SAN ANSELMO FLOOD RISK REDUCTION PROJECT

Final Environmental Impact Report
Volume 2 - Response to Comments
State Clearinghouse No. 2017042041

Prepared for
Marin County Flood Control and Water
Conservation District

Figure 3-15a
Water Surface Elevation Change With Project
100 - Year Flood Event: Fairfax Area

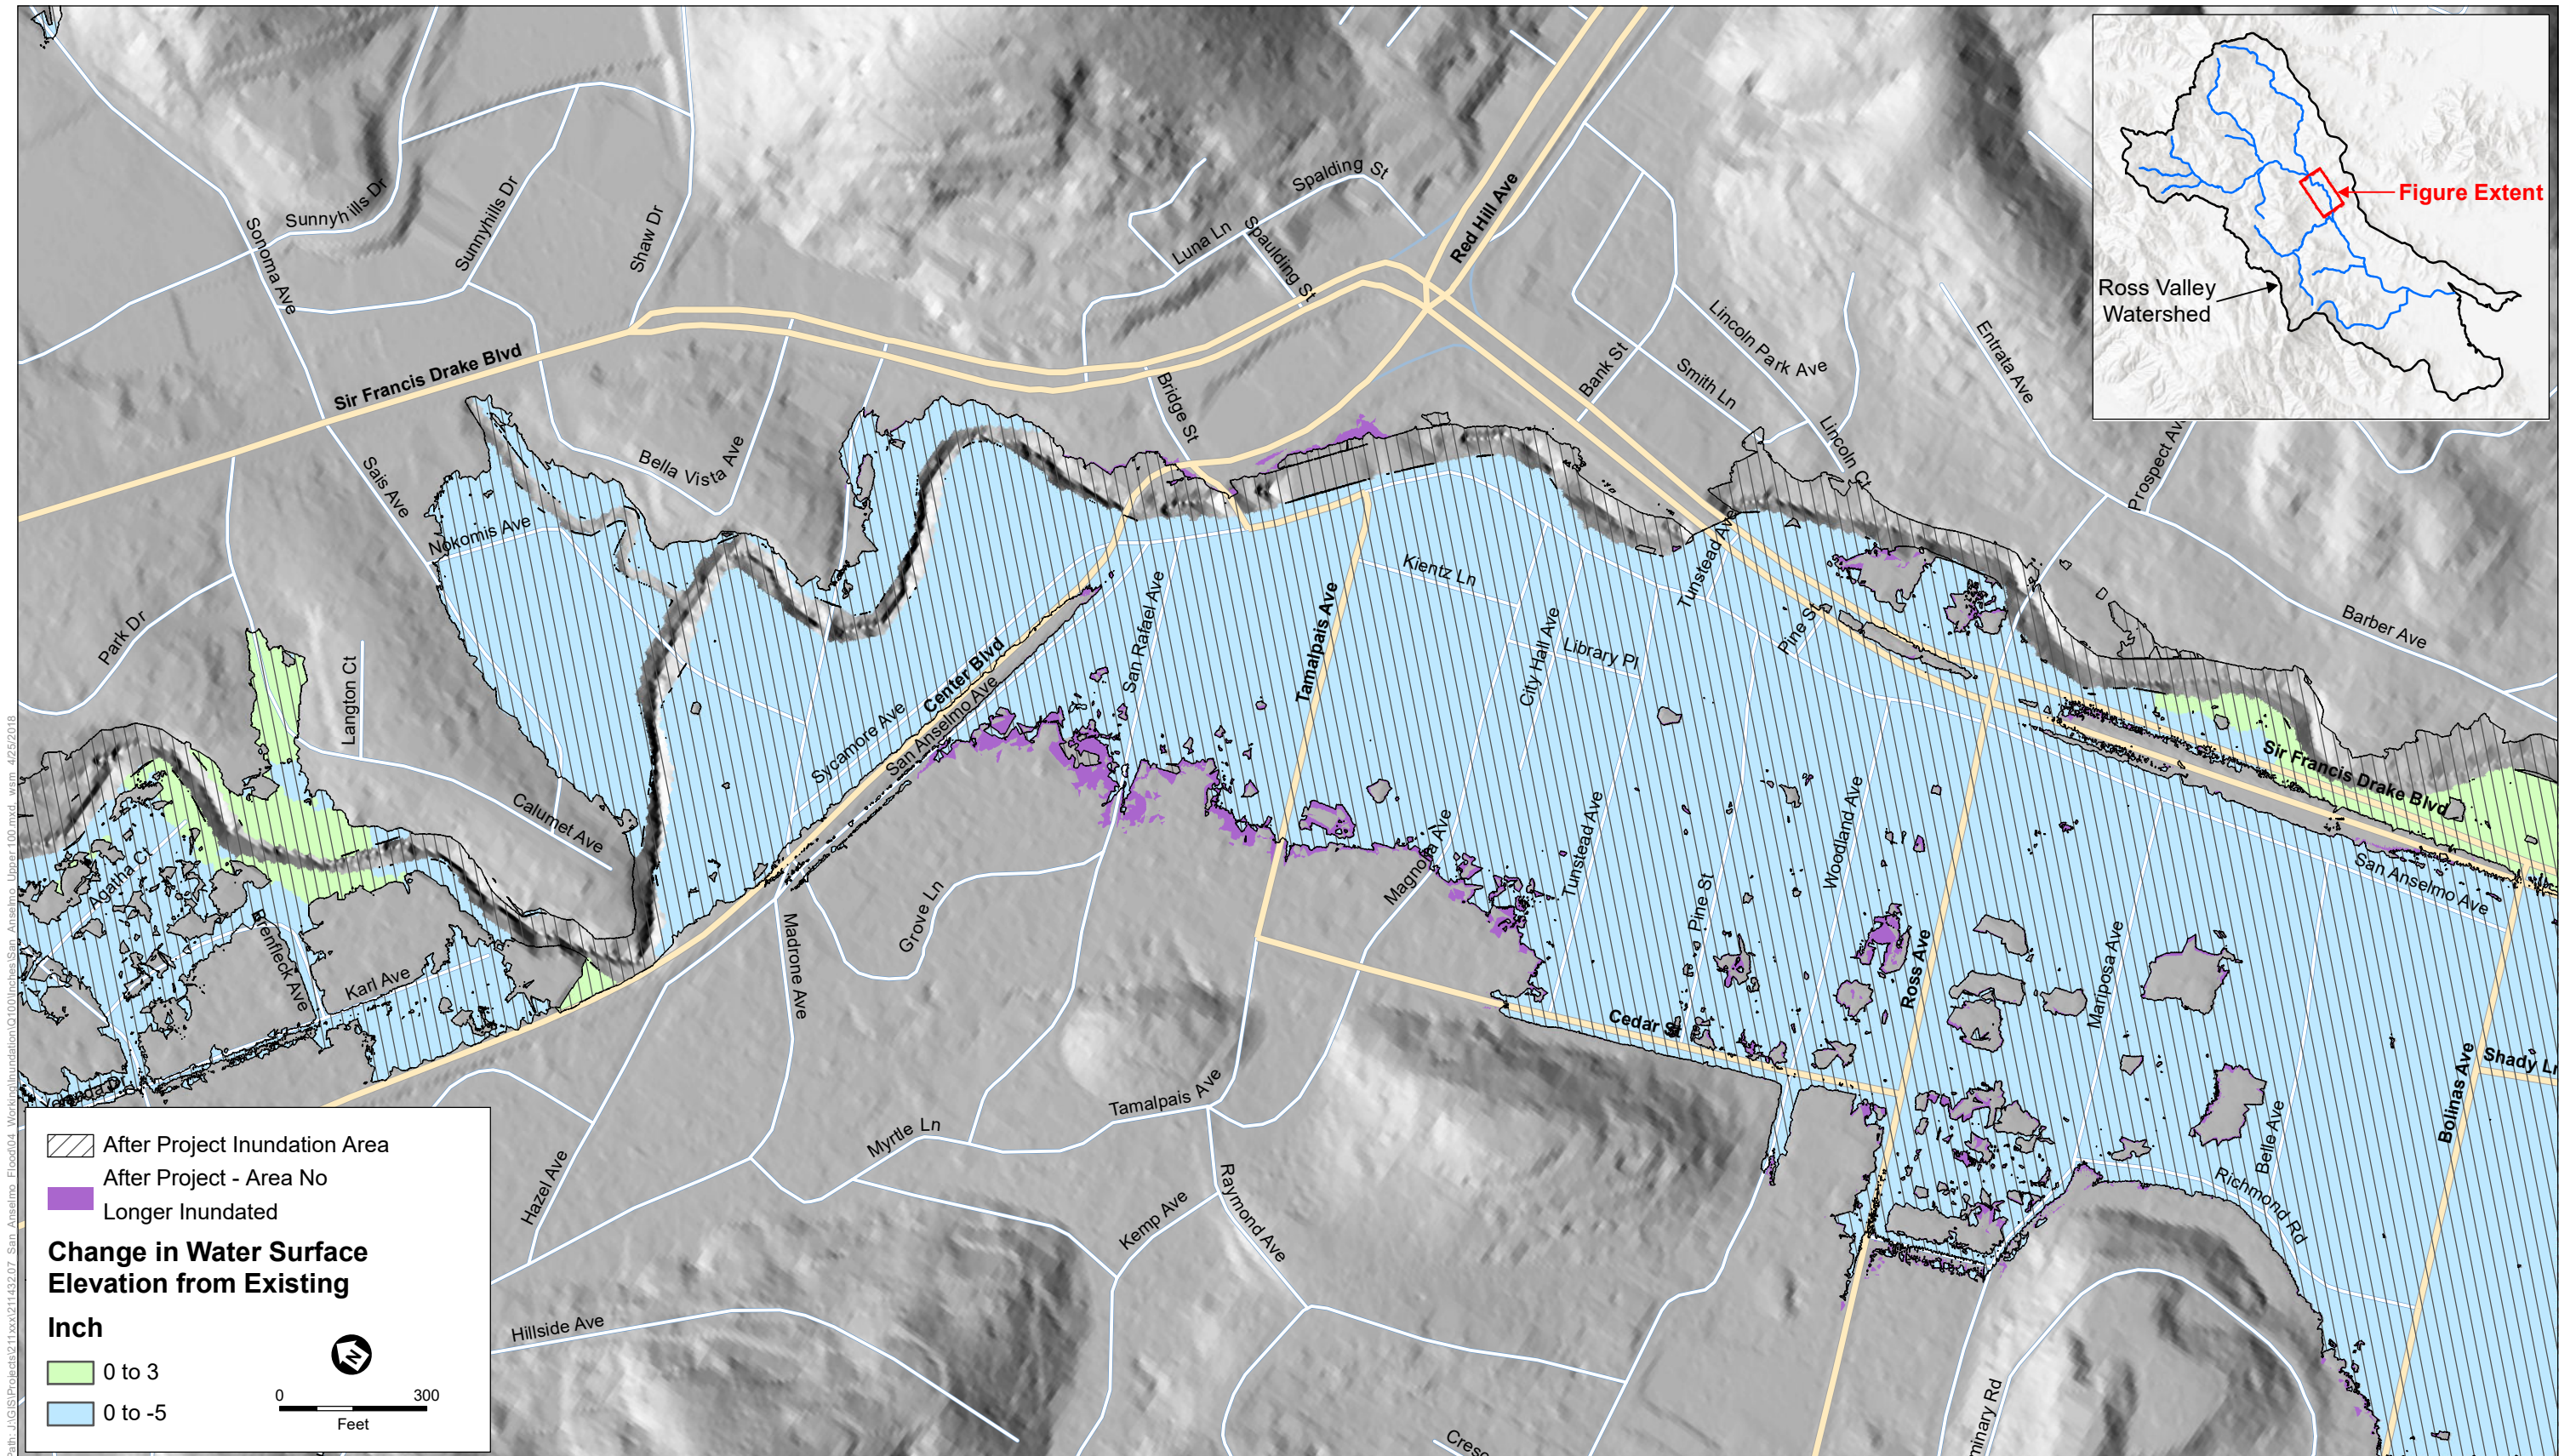
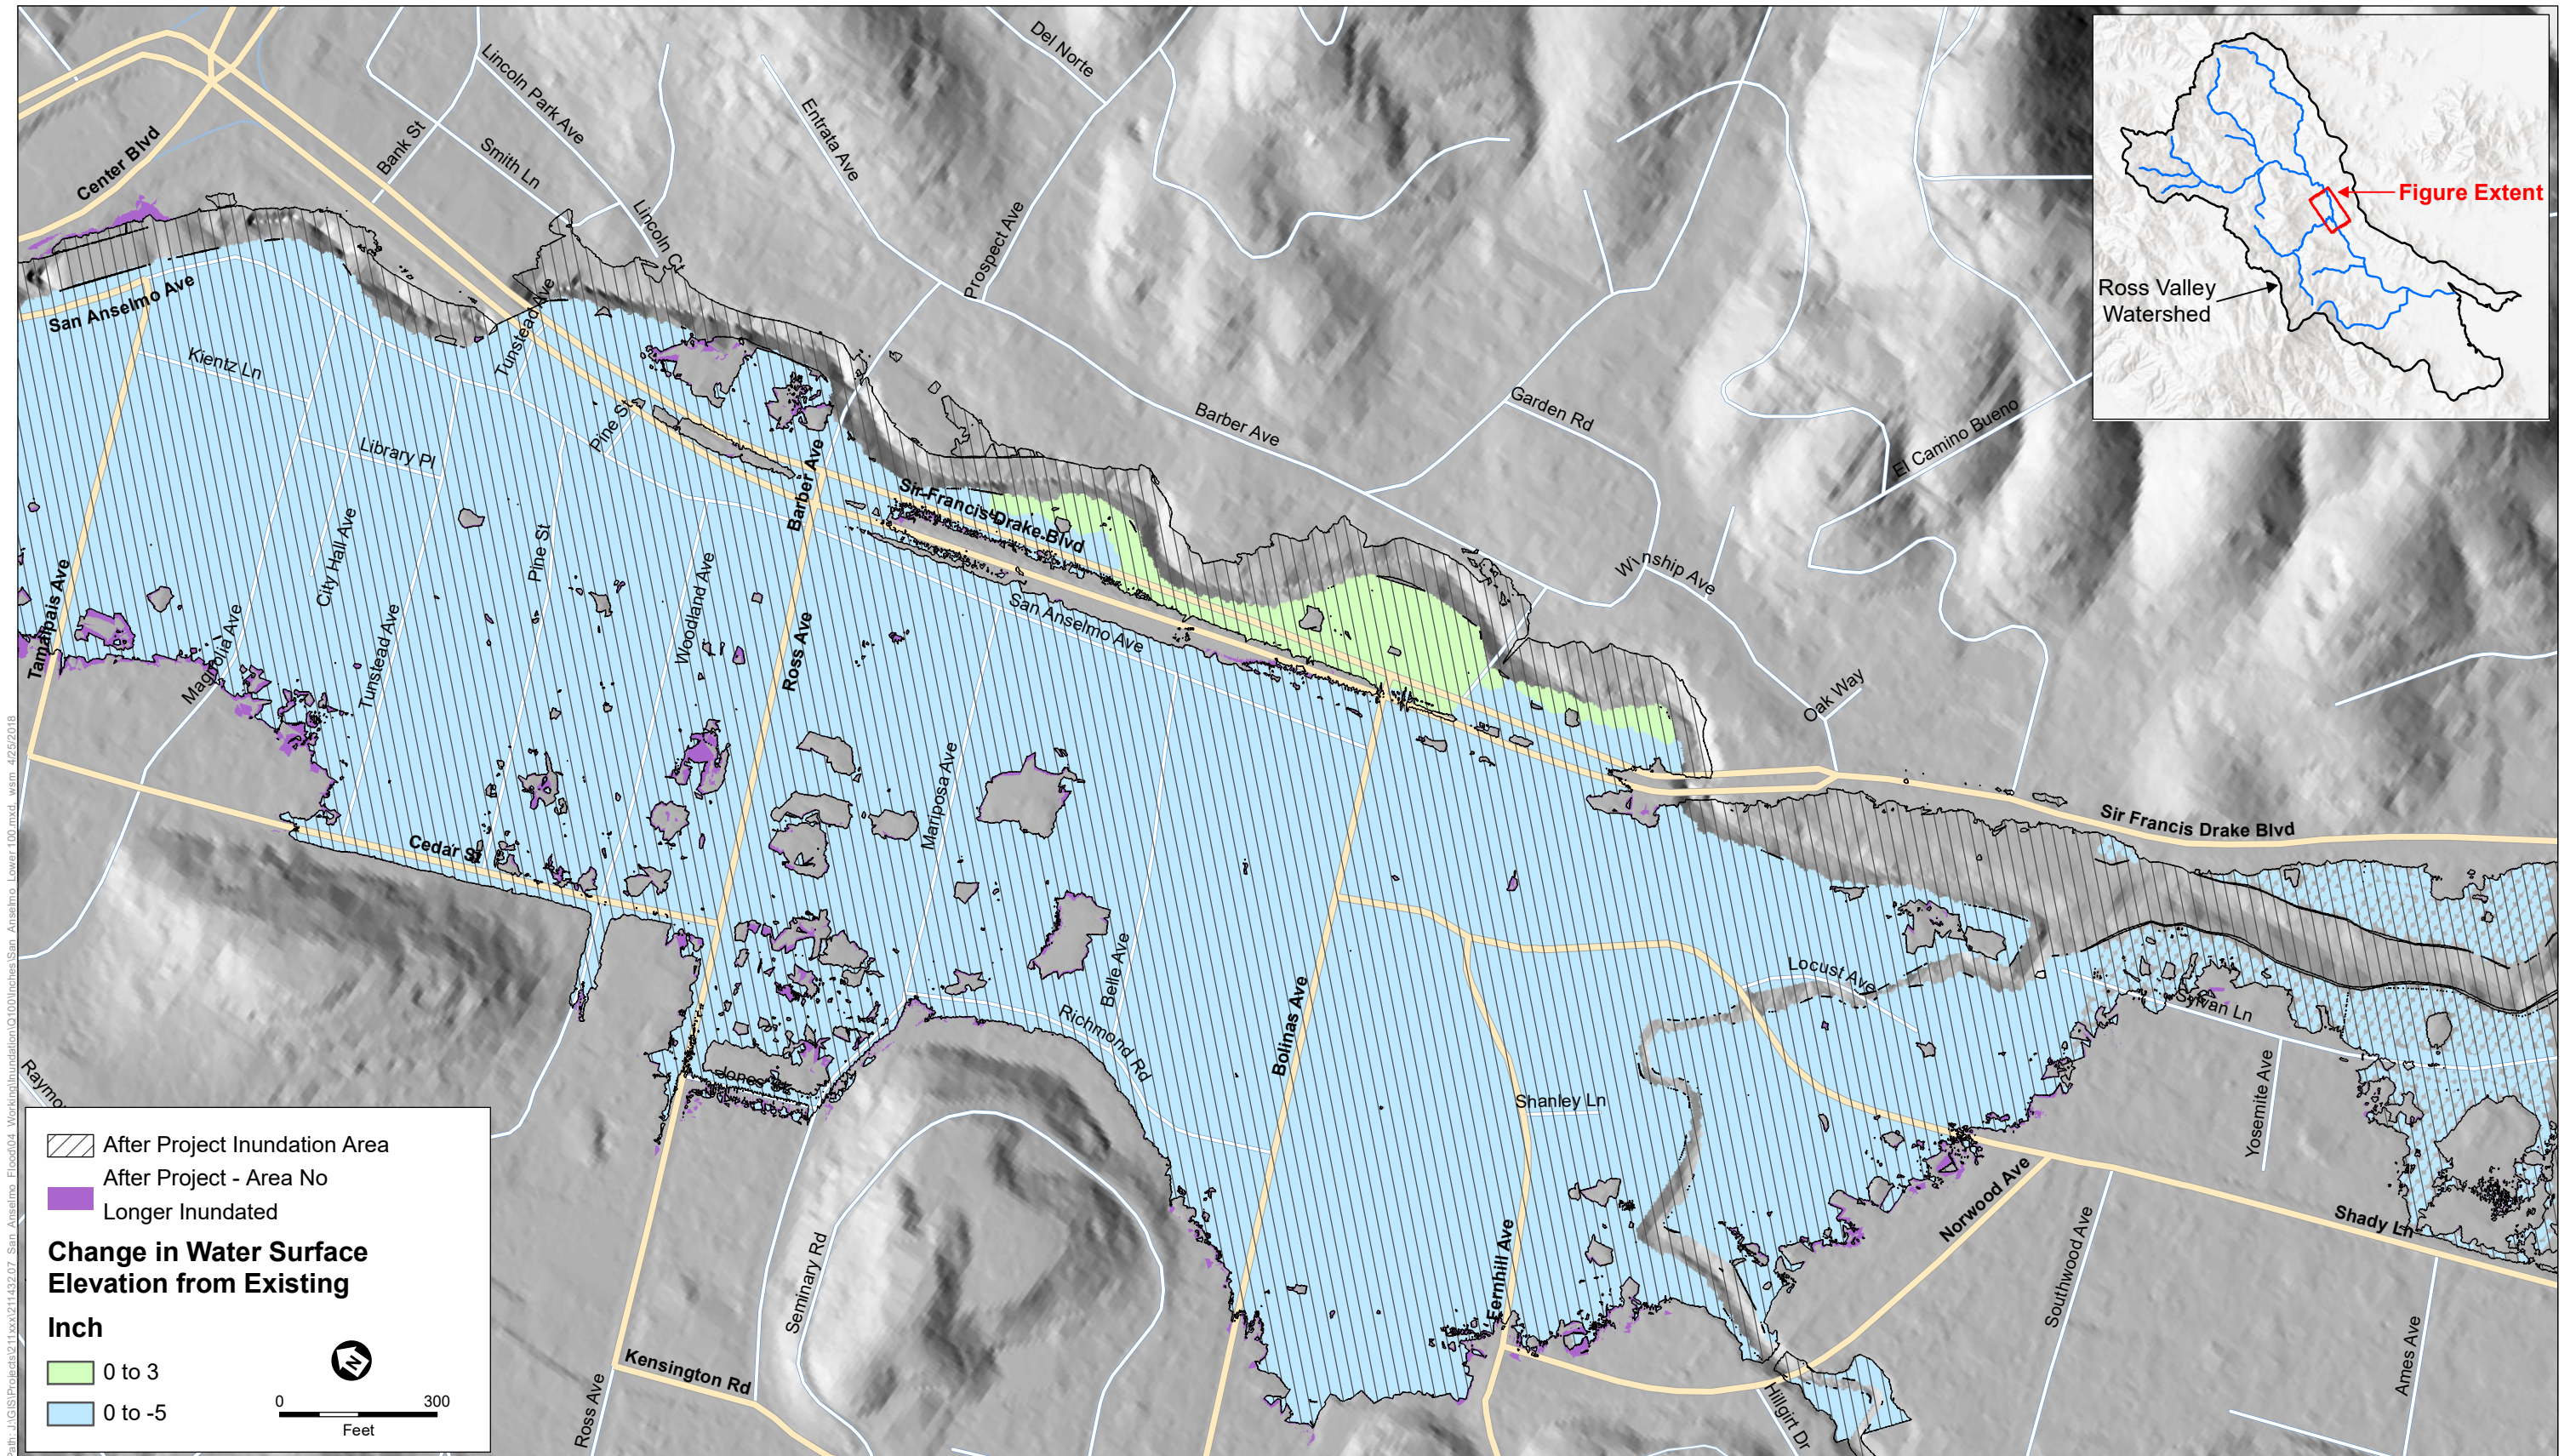
Figures in Chapter 3 (figures 3-13, 3-14, and 3-15), that show water surface elevation, change with project are not easy to interpret. It appears that the purple areas, labeled "After Project Inundation Reduction Area" would be removed from flooded areas during the specified events. However, use of the word "reduction" suggests that they would still be inundated, just to a lesser extent.

Draft EIR Figures 3-13a-c, 3-14a-c, and 3-15a-c have been revised in response to this comment. The revisions to these figures do not result in any changes to the environmental analysis in the Draft EIR.

In response to Comments B1-5 and PH-2, the legend descriptions associated with purple areas of Draft EIR Figures 3-13a-c, 3-14a-c, and 3-15a-c (Draft EIR pages 3-25 through 3-33) have been revised to read:

After Project ~~Inundation Reduction Area~~ – Area No Longer Inundated
